**State of West Virginia  
 Solicitation Response**

**Proc Folder:** 1217778  
**Solicitation Description:** Addendum 3-Ditch, Pipe, and Asphalt Repair and Maintenance  
**Proc Type:** Agency Master Agreement

| <b>Proc Folder:</b> 1217778  |                            |                         | <b>Reason for Modification:</b><br>Addendum No. 03 |

THE WEST VIRGINIA DEPARTMENT OF TRANSPORTATION DIVISION OF HIGHWAYS  
**SHOULDERS AND DITCHES**

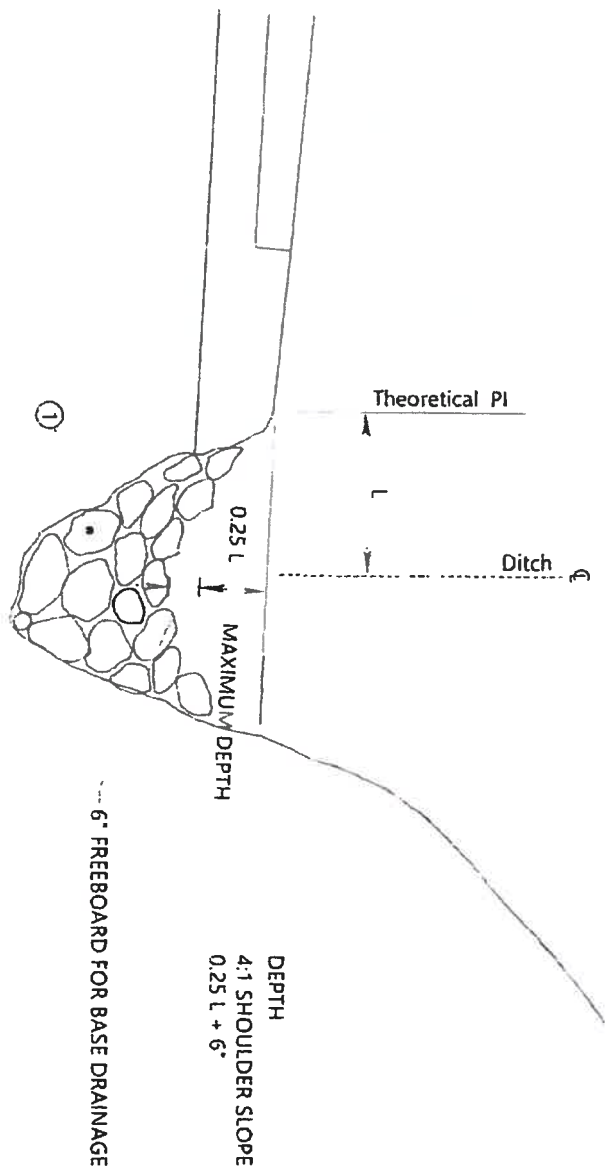
Detail on p. 37 for ditching shows grading the shoulder at a 4:1 max slope. Will this be required in areas where the existing ditches are steeper than 4:1? In some cases, this could create large amounts of earthwork and additional right of way.

If current site conditions prevent the shoulder and ditch from being shaped per the contract specifications, the District Engineer or their designee shall provide the required shoulder and ditch geometry during the delivery order or prior to commencement of work on the section of ditch line in question.
